Re: Certification Submittal for Final Building Certificate of Occupancy for  
Ventana Square Storage Units, [B-10 / D6]  
2500 Paradise Blvd  
Architect's Stamp Dated 11/21/03

The TCL / Letter of Certification submitted on November 20, 2003 is sufficient for acceptance by this office for final Certificate of Occupancy (C.O.). Notification has been made to the Building and Safety Section.

TRACT H SITEPLAN FOR BUILDING PERMIT

PROJECT TITLE: **Ventana Square**

sheet: **A2.1A**

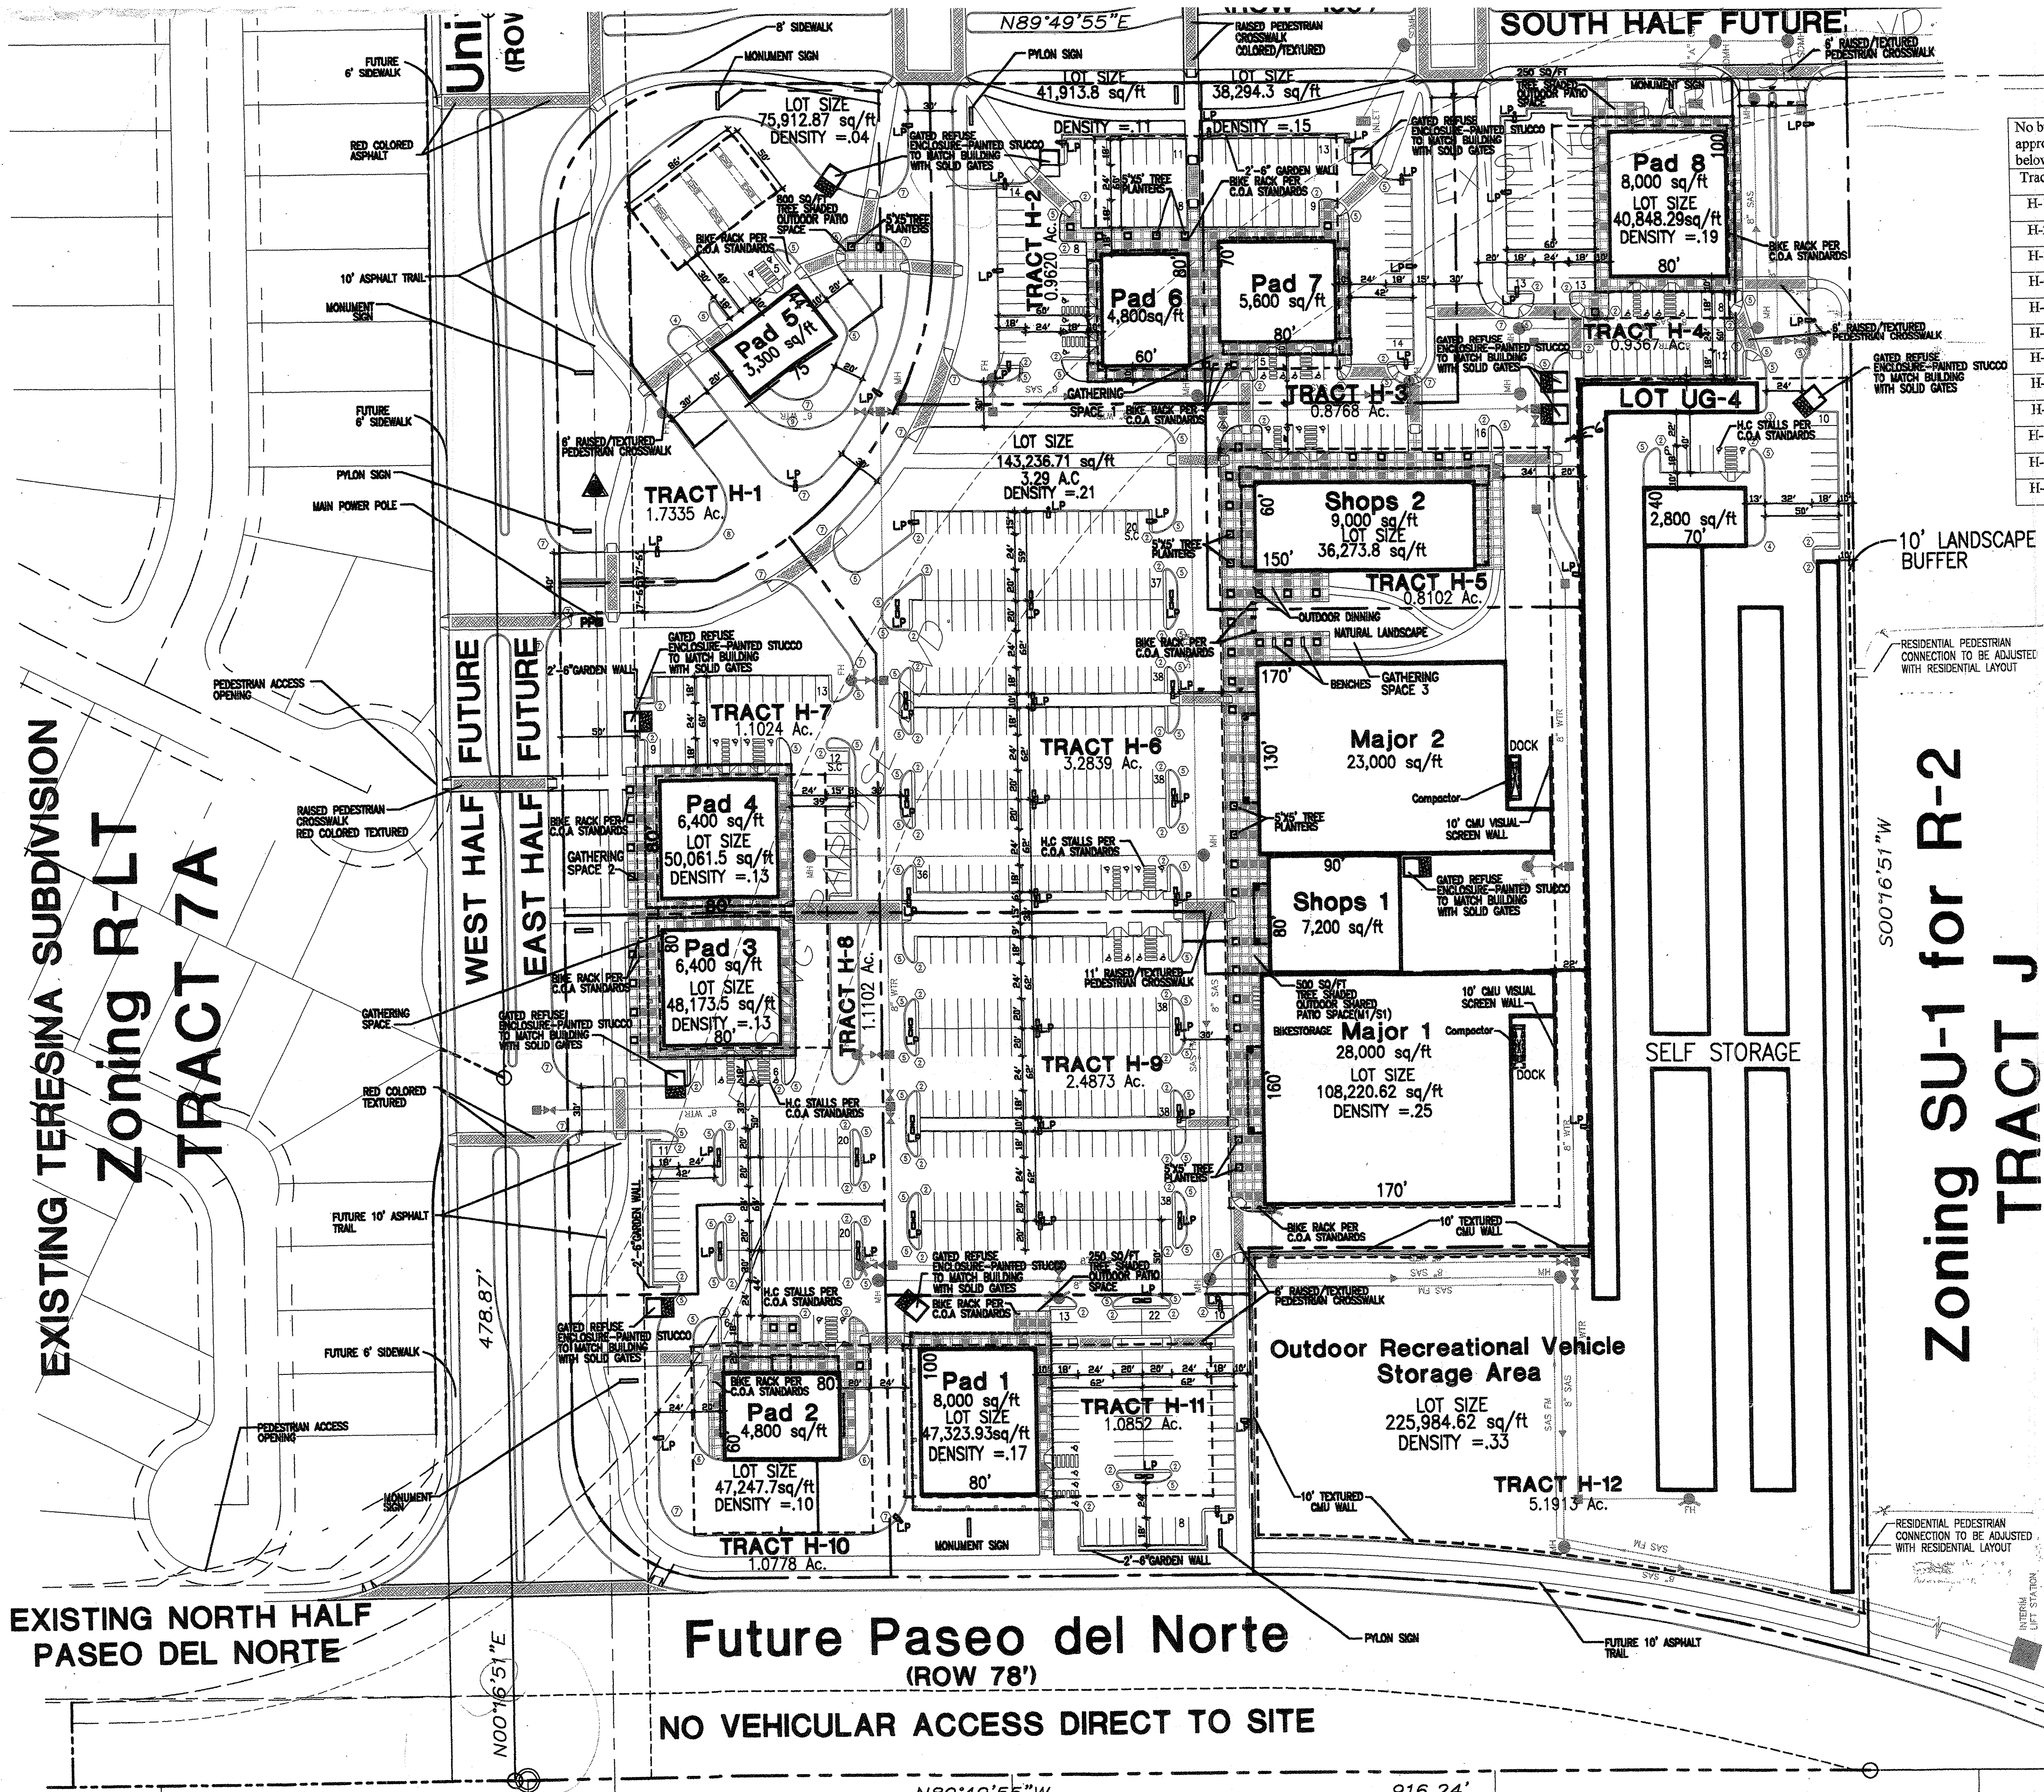
2. The following clarifications and additions to the site development plan shall be addressed:
- a. The note regarding alternate uses shall be placed on the landscape plan, gathering spaces, grading and drainage plan, utility plan, and all elevation sheets.

- b. Elevations that are also alternate use elevations shall be clearly labeled as such.
3. The submitted site development plan for building permit shall adhere to the existing guidelines and requirements found in the site development plan for subdivision as well as the additional guidelines and requirements outlined in the site development plan for subdivision Conditions of Approval (00128 00000 00409).

4. Pedestrian and bicycle amenities:
- a. Speed humps/bumps shall be utilized on both sides of the internal pedestrian crossings of drive aisles or each crossing shall be a raised table, three inches above the drive aisle.

- b. Two additional pedestrian links shall be added to Tract G: one from the northwest corner of the site to Major 4 and another connection Shops 4 and Major 5.

- c. These pads shall connect to the residential area to the east. There shall be direct pedestrian connections between Pads 7 and 8 and shops 2 at the northeast corner of Tract H. The path which begins in the Gathering Space between Major 2 and Shops 2 shall connect to pads 7 and 8. These paths shall connect to the residential area to the east.

- d. Adequate bicycle parking shall be shown at Shops 3 and Pads 4 and 6.
5. The height of the lighting poles shall be reduced to 24' maximum and a maximum of 20 feet high within 300 feet of a residential zone.

6. Landscaping:
- a. The major east-west, pedestrian walkway between Majors 3 and 4 on Tract G shall have additional shade trees planted along its entire length similar to the major east-west pedestrian walkways on Tract H.

- b. The entire, eastern setback of Lot UG-4 shall be increased to at least ten feet to allow for a ten-foot-wide landscaping buffer between the subject site and the adjacent, residential zoning to the east.

- c. Any gravel used shall be compatible with the appearance (colors & materials) of the project.
- d. Screen or garden walls, 2 1/2 - 3 feet high with colors and texture that are contextual with the building materials shall be located along all parking areas that front on a roadway or street.

7. Elevations and signs:
- a. The color of the roof tiles shall be specified.
- b. The color of the building cornices shall be specified.
- c. All loading dock and receiving areas shall be visually screened with walls and roofs that integrate with the building architecture; roofs over loading docks are limited to those docks facing residential zoning.

- d. In addition to a ten foot landscape buffer, the eastern edge of Lot UG-4 shall have a minimum eight foot high, solid wall along its entire length.

- e. Variations in the surface of the exterior walls and/or display windows as per the additional design requirements shall be added to the building elevations. The areas between the stucco control joints shall have the same medium tan color as the CMU base.

- f. Colors and materials of the signs shall match those of the buildings and be called out on the detail diagrams.
- g. Freestanding signs are limited to a maximum height of 16 feet.

8. The comments and conditions of the Parks and Recreation Department shall be addressed:
- a. The applicant shall take the trail design and any landscaping adjacent to Paseo del Norte to the Parks & Recreation Department for review and approval prior to final DRB approval.

- b. The 10' asphalt trail along universe, outside the right of way but within a utility easement shall be clarified as either a trail or a sidewalk. In its northern section, between Paradise and the channel, there shall be a 5' separation between the trail and the curb.

9. Conditions of the Public Works Department:
- a. The entrance in the immediate proximity of Major No. 4 must be reconfigured and channelized to better define traffic patterns and placement of control devices.

- b. The site access, circulation patterns, structure orientation / configurations must be constructed to the satisfaction of the Traffic Engineer.
- c. Location of walls, fences, refuse containers and signs must meet the clear sight distance requirements for adjacent streets and internal circulation aisles.

- d. Provision of adequate pedestrian circulation with handicapped features within the site and to the adjacent streets, i.e., pedestrian linkages between pads major tenants.

- e. The site plan must identify surrounding uses and provide dimensions where appropriate, i.e., structures, streets, medians, drive aisles, parking spaces, walls, signs, etc.

- f. Provision of street trees and landscaping on Paseo del Norte, Paradise and Universe Boulevards.
- g. Location and dimension of proposed fire lanes must meet Fire Code requirements as per the DPM.

- h. Coordination with the Solid Waste Department with regard to refuse container location and access.
- i. Details related to 1) access along Paradise Boulevard, and 2) bikeway facilities and associated rights-of-way along Paradise Boulevard and Paseo del Norte shall be addressed to the satisfaction of the Parks & Recreation and Public Works Departments prior to final sign-off at the DRB.

- j. An availability statement from New Mexico Utilities Inc. will be required. Required infrastructure must be financially guaranteed prior to site plan and/or plot approval by the Development Review Board. All infrastructures must be designed to City of Albuquerque standards, including water and/or sanitary sewer lined owned and operated by NMUI.

- k. The utility plan will address potential conflicts, including: The sanitary outfall appears to be routed through a storm sewer manhole; Status operation and maintenance responsibilities for the "temporary lift station" must also be addressed. These issues must be resolved prior to DRB action.
